Coffs Harbour Bypass

Submissions Report

Volume 1. Executive summary, Chapters 1-3

Coffs Harbour Bypass
 Native vegetation
 Figure 3.4-1-01

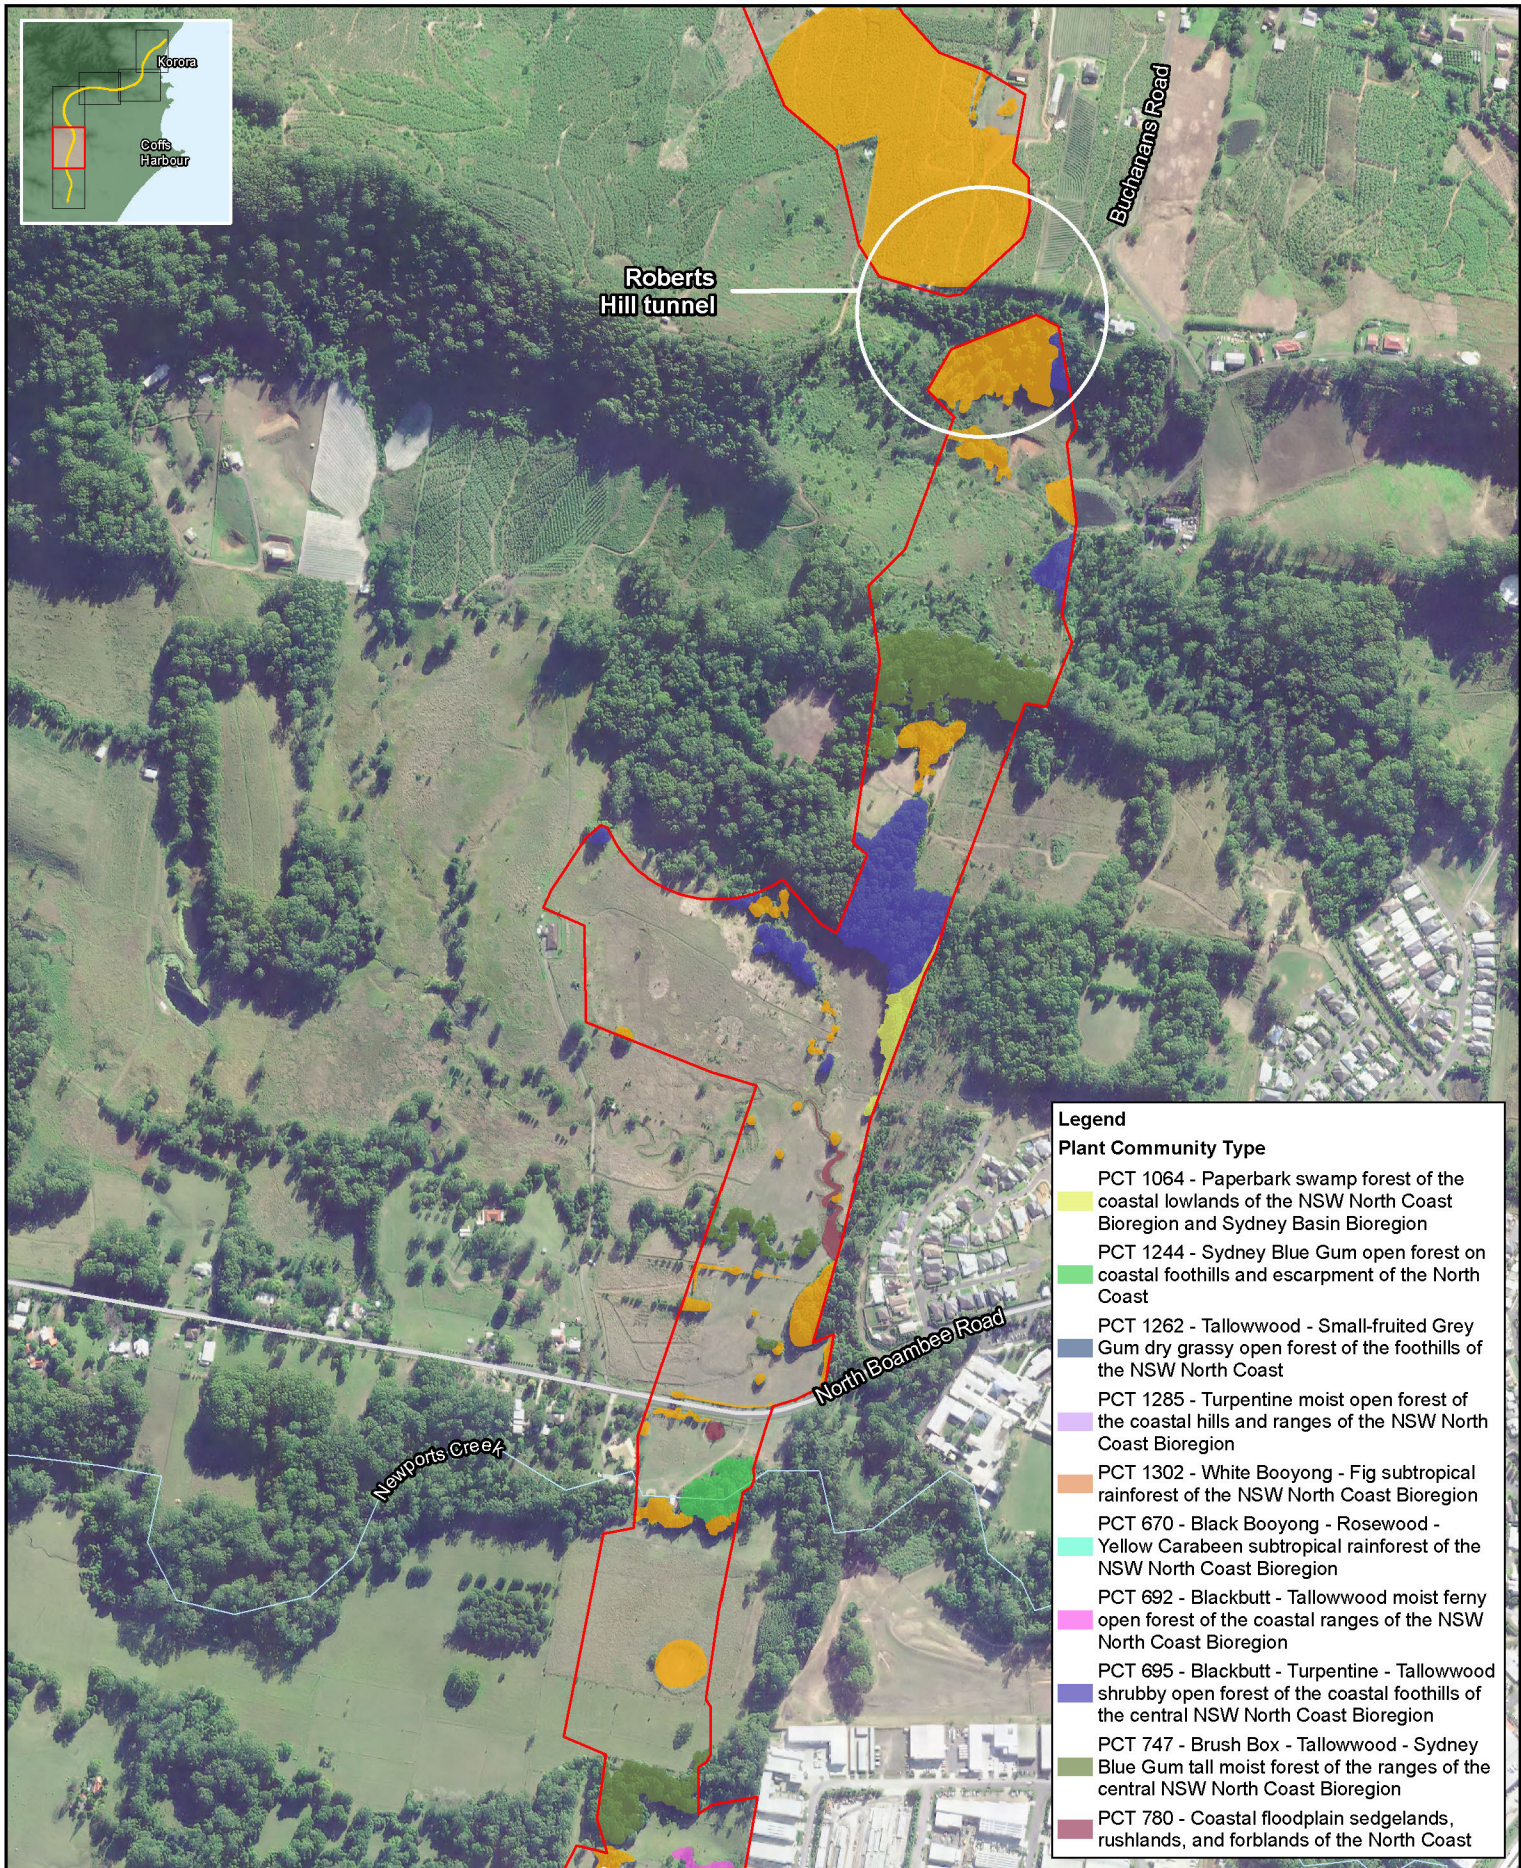
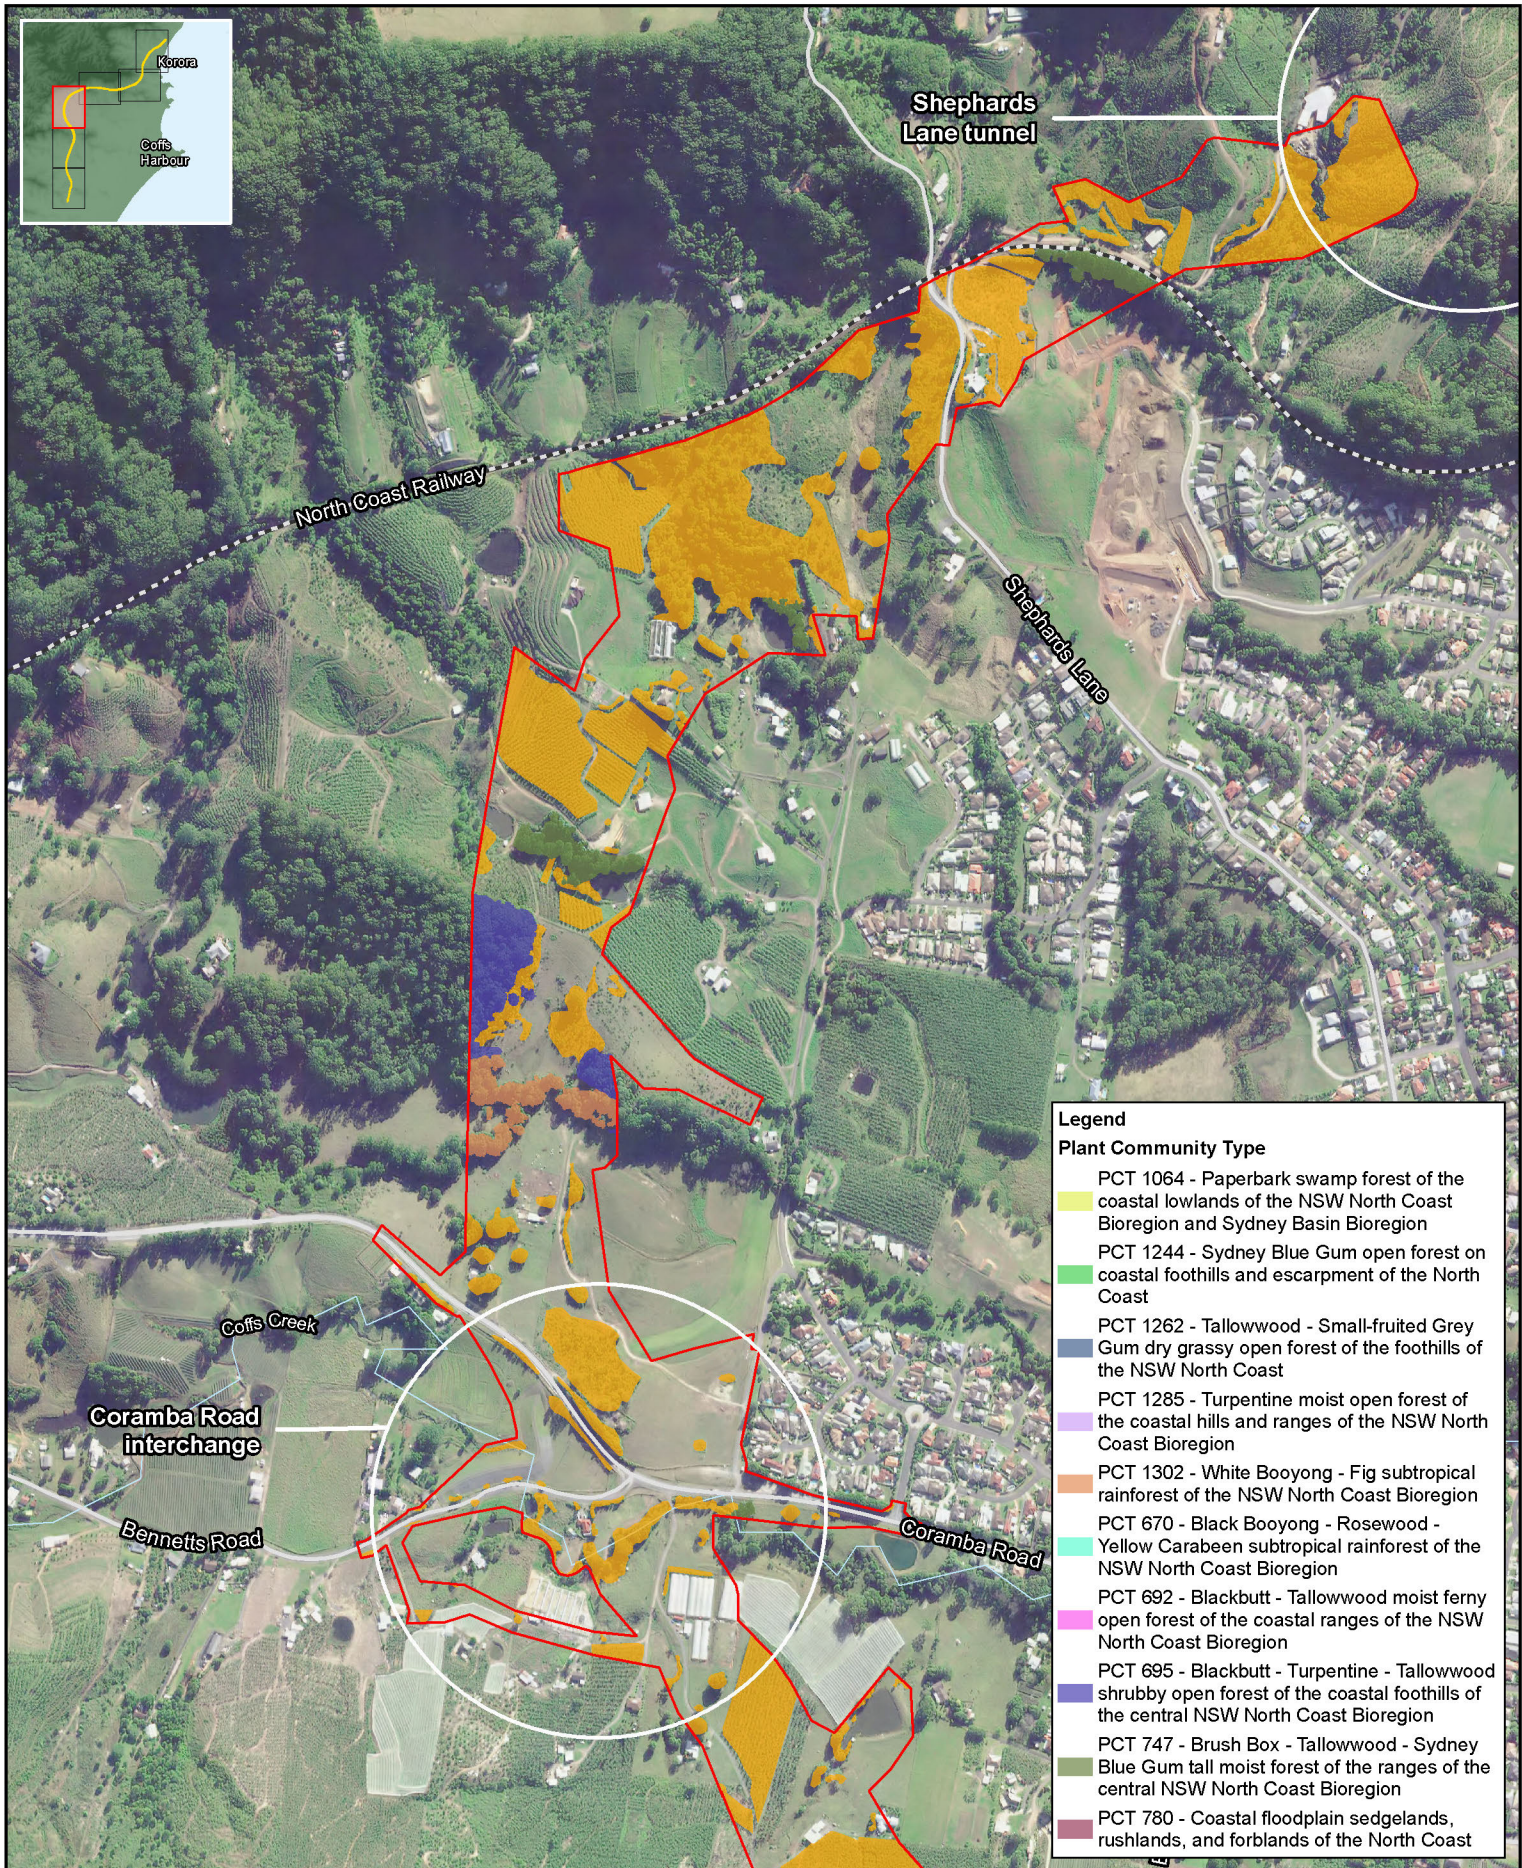
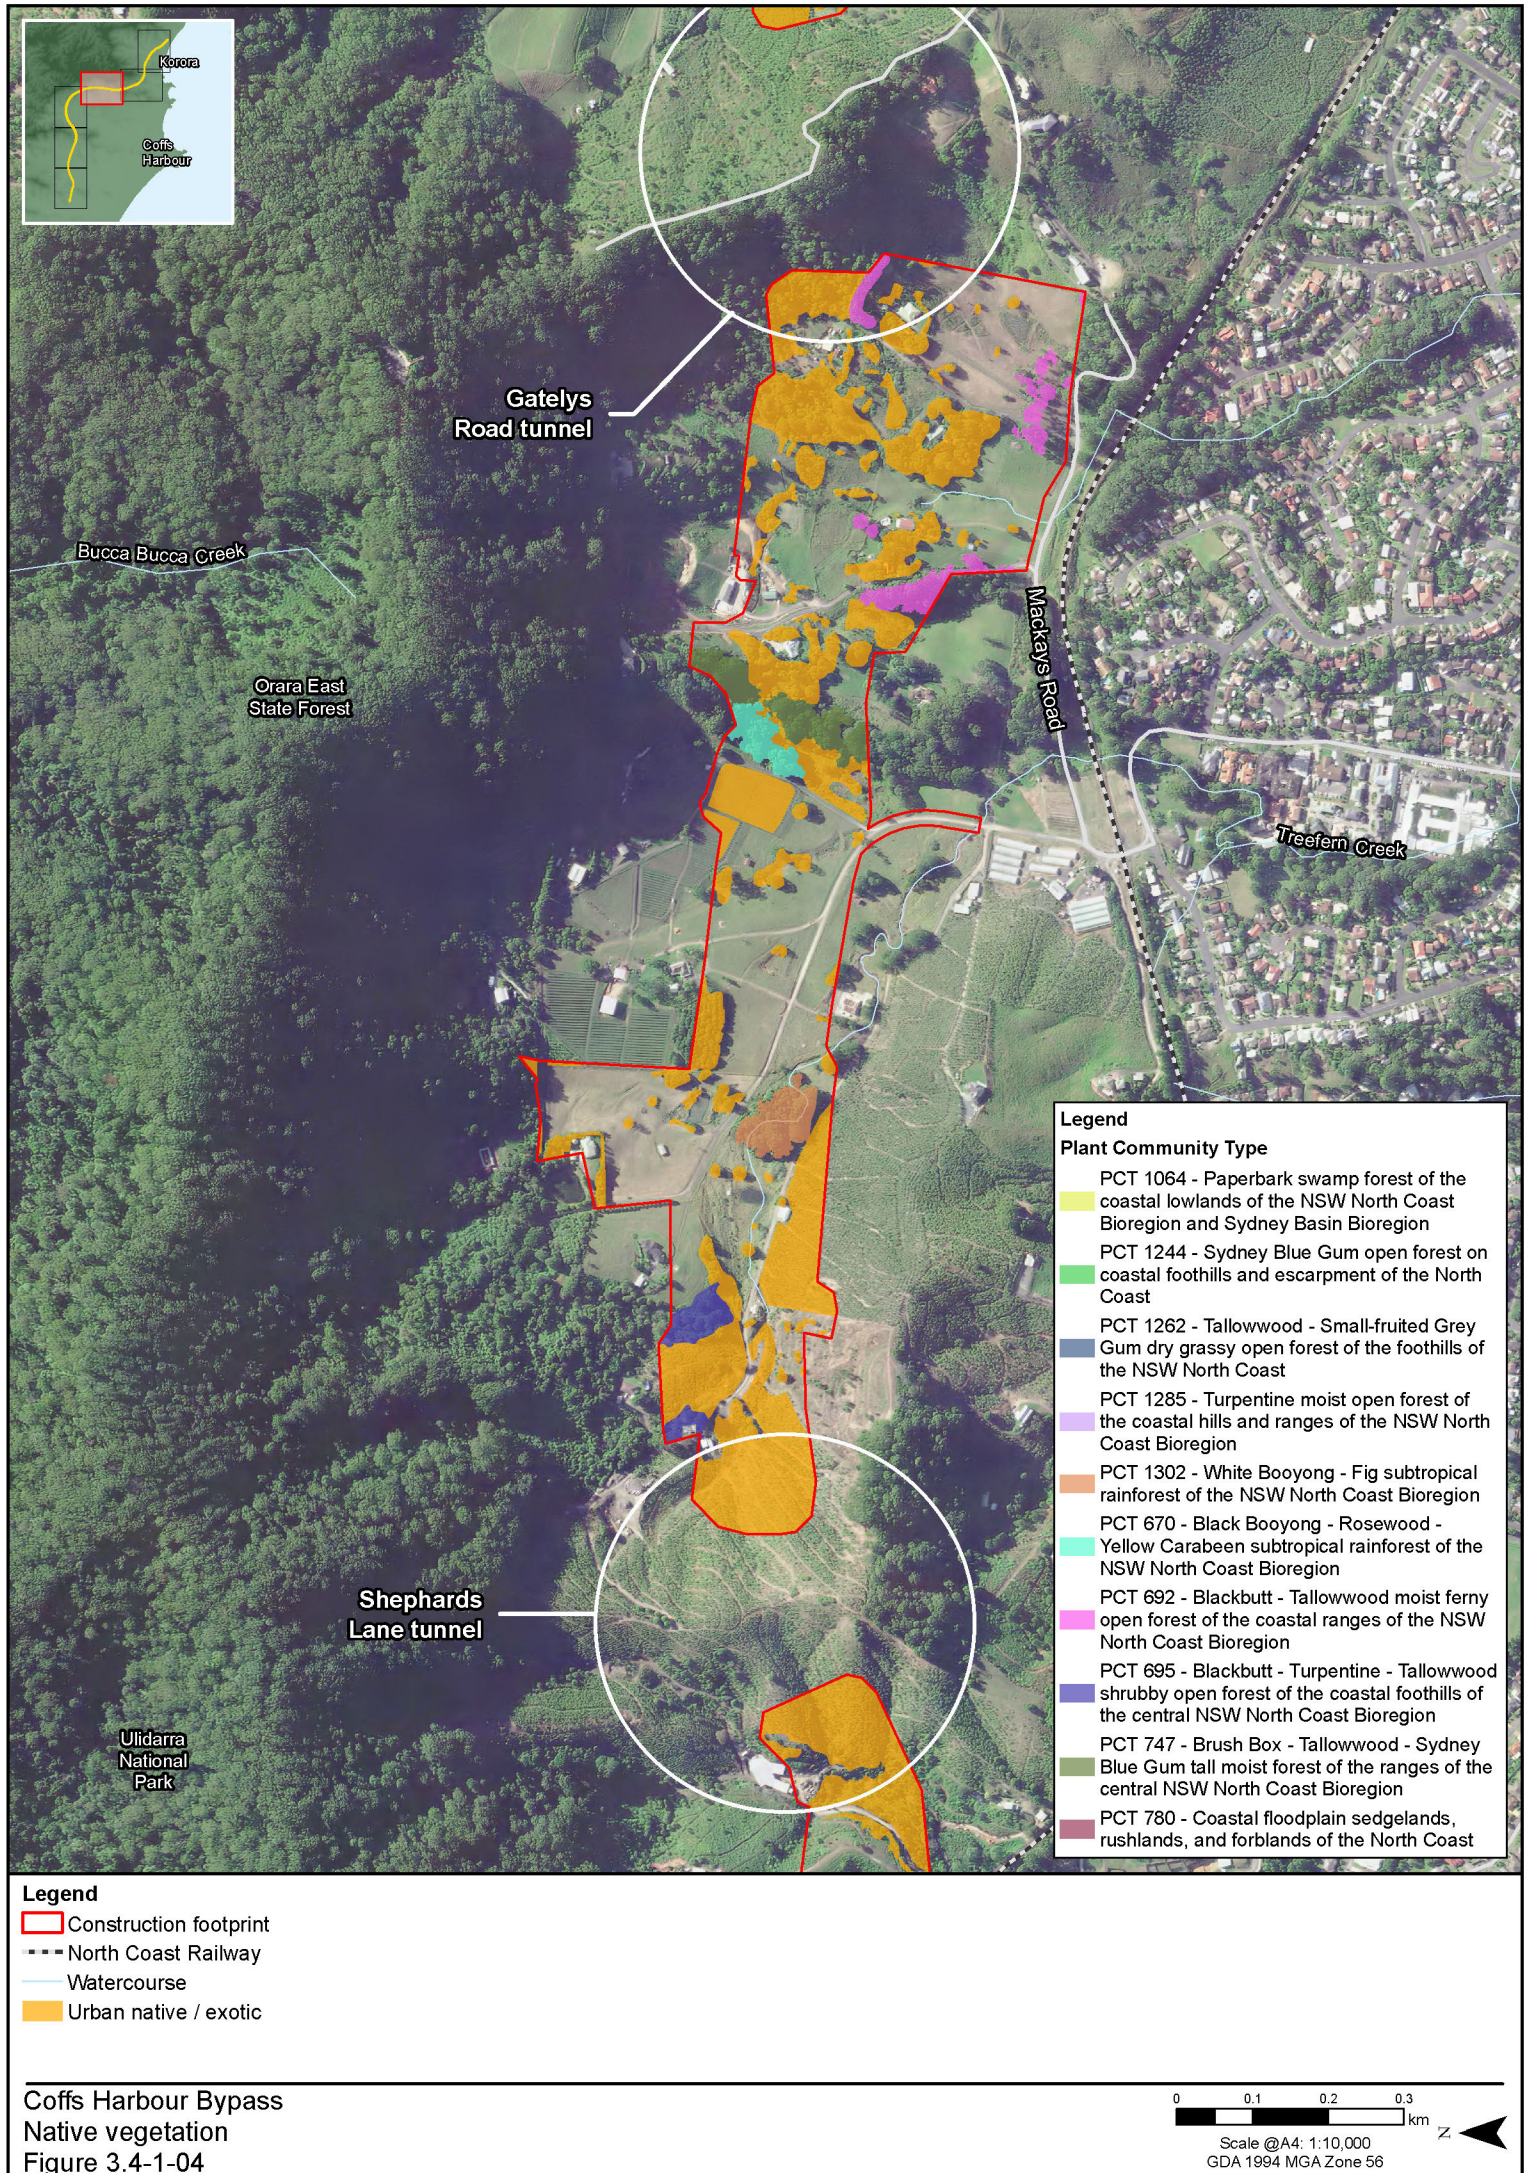
- Any areas of freshwater wetland within the development site must be mapped and assessed, and the results presented in the Biodiversity Assessment Report
- Any freshwater wetlands identified must be assessed to determine whether they align with the freshwater wetland on coastal floodplains endangered ecological community (EEC) determination.

- The two patches of wetland vegetation, north and south of North Boambee Road, have been added because of a change in the condition of the vegetation since the original PCT mapping was carried out in 2016. These areas are described in detail in Section 3.1.2 of Appendix C, Updated biodiversity assessment report of the Amendment Report and shown on Figures 4.1 to 4.7. Locations of updated PCT 780 are provided in **Figure 3.4-1-01** to **Figure 3.4-1-06**.

These areas are described in detail in Section 3.1.2 of Appendix C, Updated biodiversity assessment report of the Amendment Report and shown on **Figure 3.4-1-01** to **Figure 3.4-1-06**.
